HYDROLOGIC ANALYSIS FOR:

CROCKER TPM 20743

REVISED
SEPTEMBER, 2004

Re: Hydrologic Analysis for Crocker TPM 20743

FIGURE 3

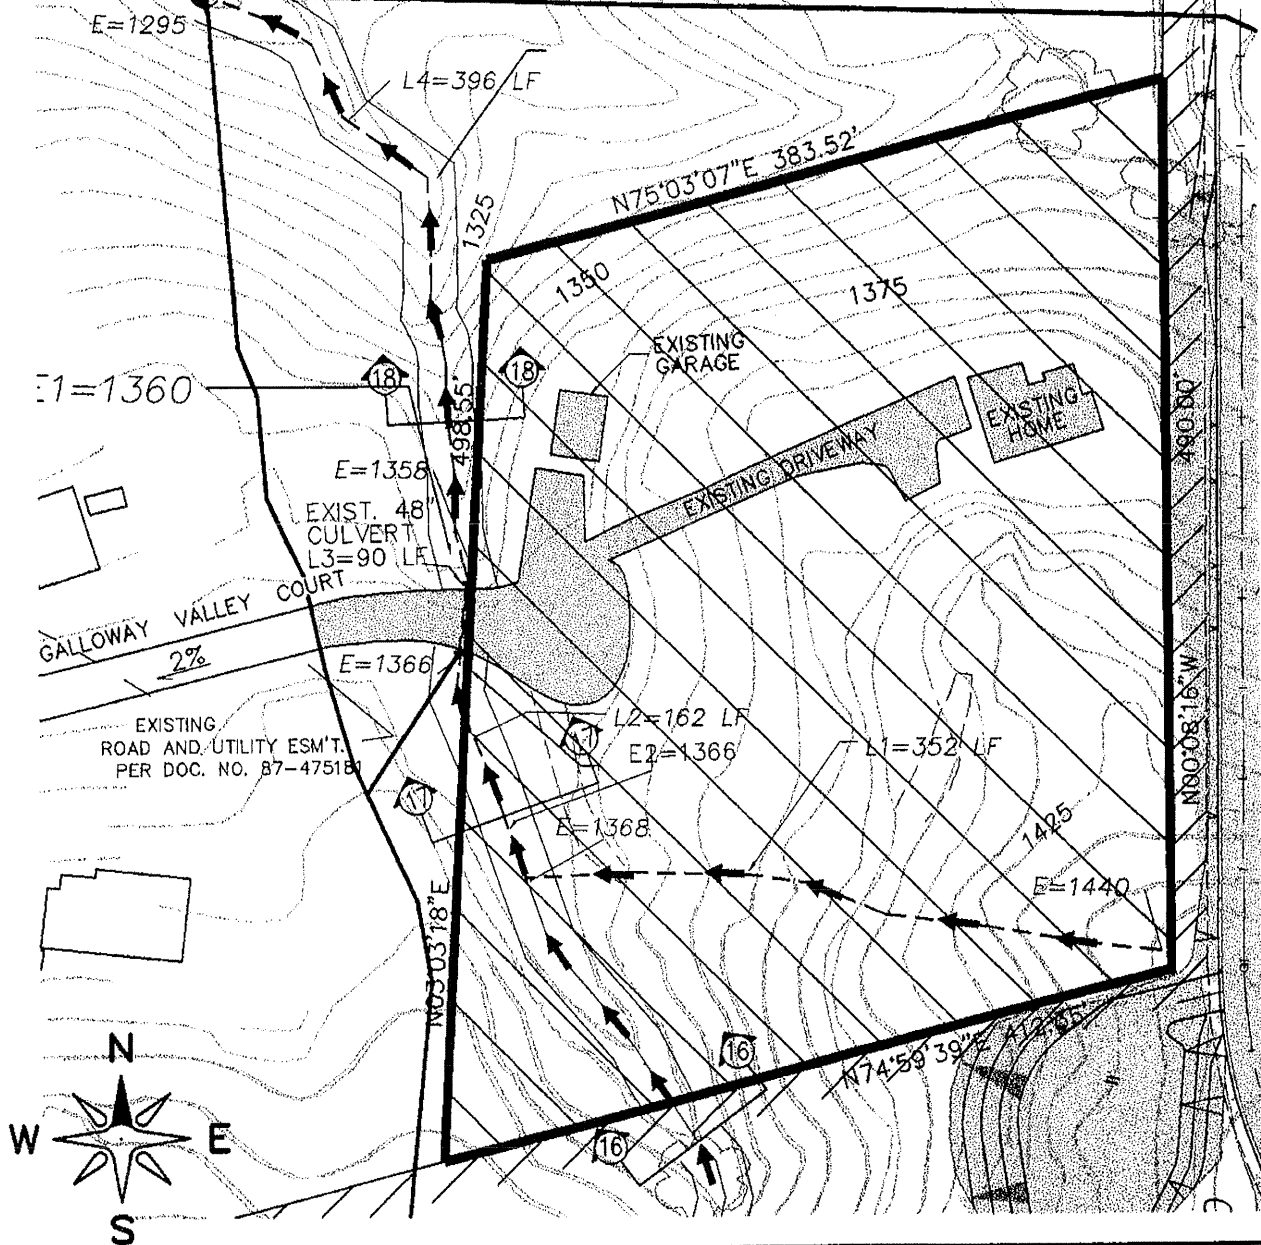
- Pre and post development Q's were done for the entire basin. Perform similar calculations for the Lot only to show the effect of increase in % impervious within the lot. Refer to Section 6.1 and Figures 3 and 4 in the Hydrologic Report.

An initial time of concentration (T_i) was based on a maximum overland flow length of 100 feet and travel time (T_t) was calculated through the watershed using the overland flow equation, and channel flow analysis from Haestad Methods Open Channel Flow Module, Version 3.3 © 1991. The T_c for the Crocker Parcel in the existing condition was determined to be 10 minutes with a corresponding peak flow rate of 7.5 cfs (Figure 3).

DISCHARGE CROCKER PARCEL
 $T_c = 10.0 \text{ min}$
 $Q_{100} = 7.6 \text{ cfs}$
 $\text{Area} = 4.3 \text{ AC}$

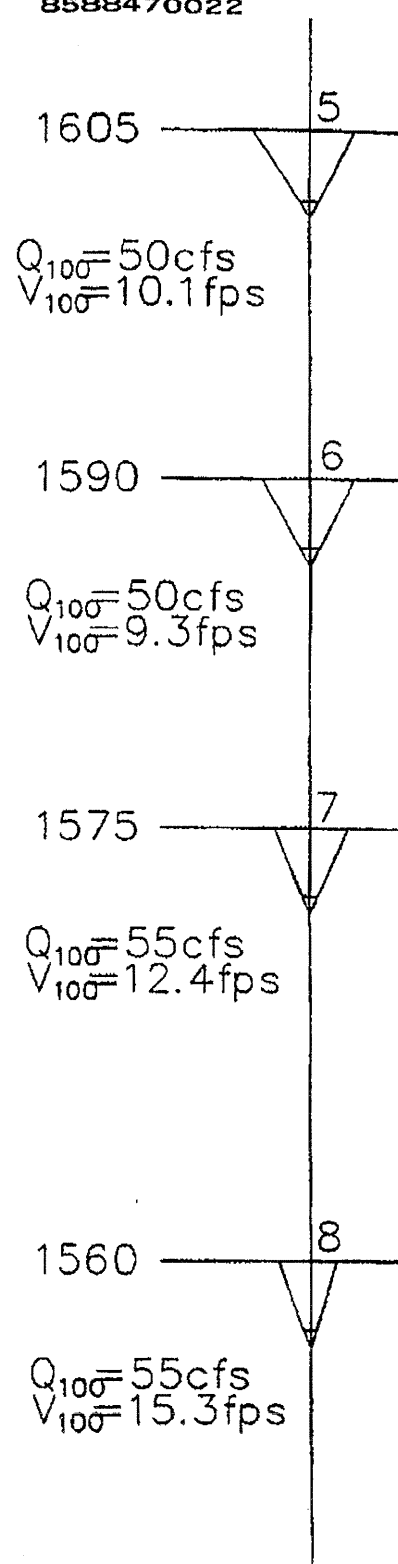
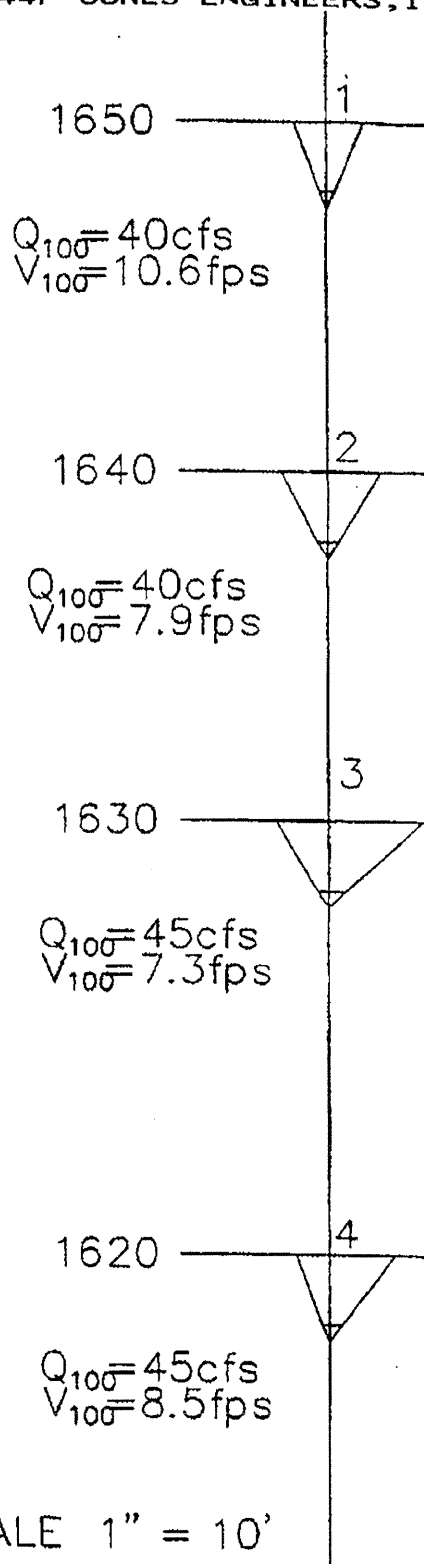
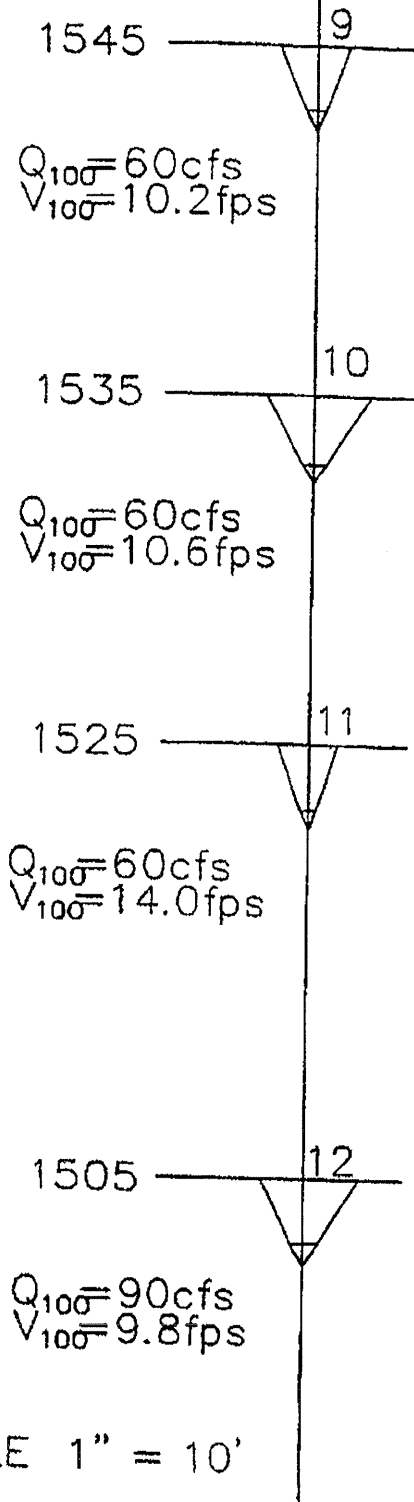
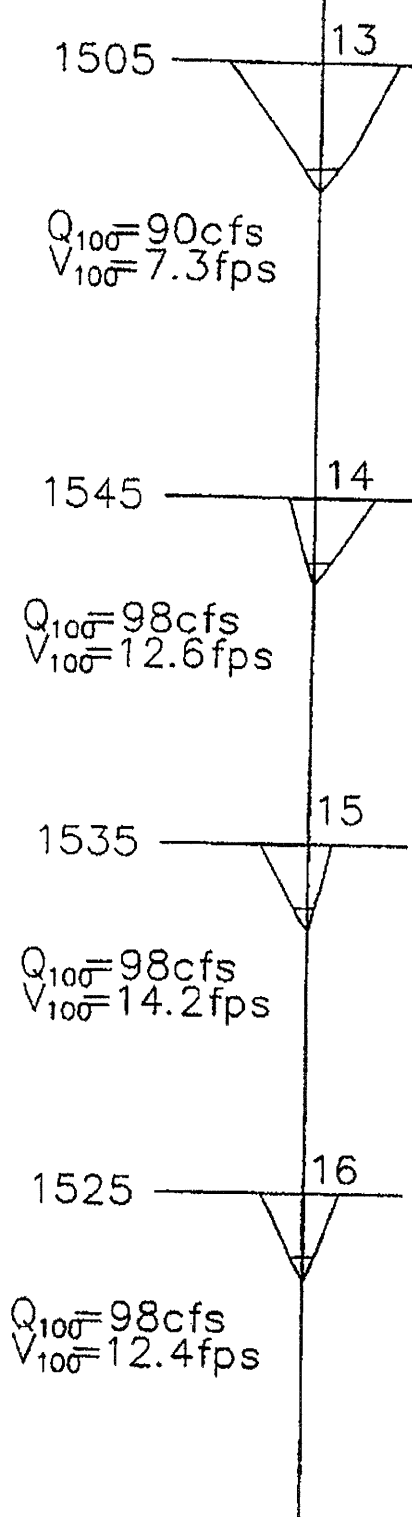
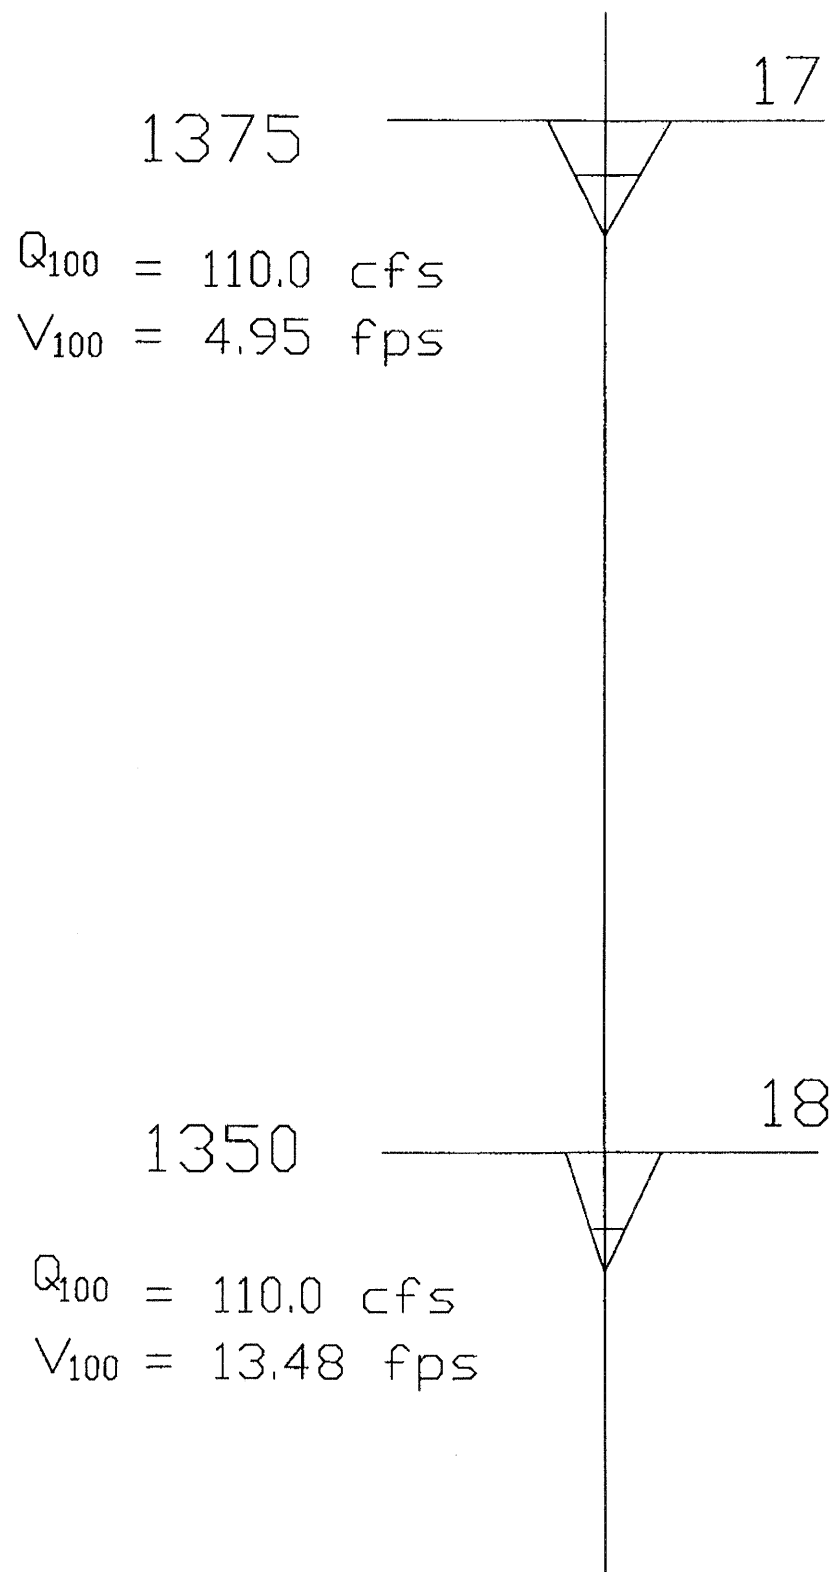
- Cross section stop at the southerly property line. Continue cross section analysis along the creek within the property to the point affecting the westerly property line. Analysis for continuation of 100 yr flood line of inundation and added cross sections are located in Appendix II (Section 17 and 18).

Left Side Slope	<u>5.1 :1 (H:V)</u>
Right Side Slope	<u>5.7 :1 (H:V)</u>
Manning's n	<u>0.030</u>
Channel Slope	<u>0.010 ft/ft</u>
Discharge	<u>110.0 cfs</u>

Left Side Slope	<u>4.7 :1 (H:V)</u>
Right Side Slope	<u>3.2 :1 (H:V)</u>
Manning's n	<u>0.030</u>
Channel Slope	<u>0.120 ft/ft</u>
Discharge	<u>110.0 cfs</u>
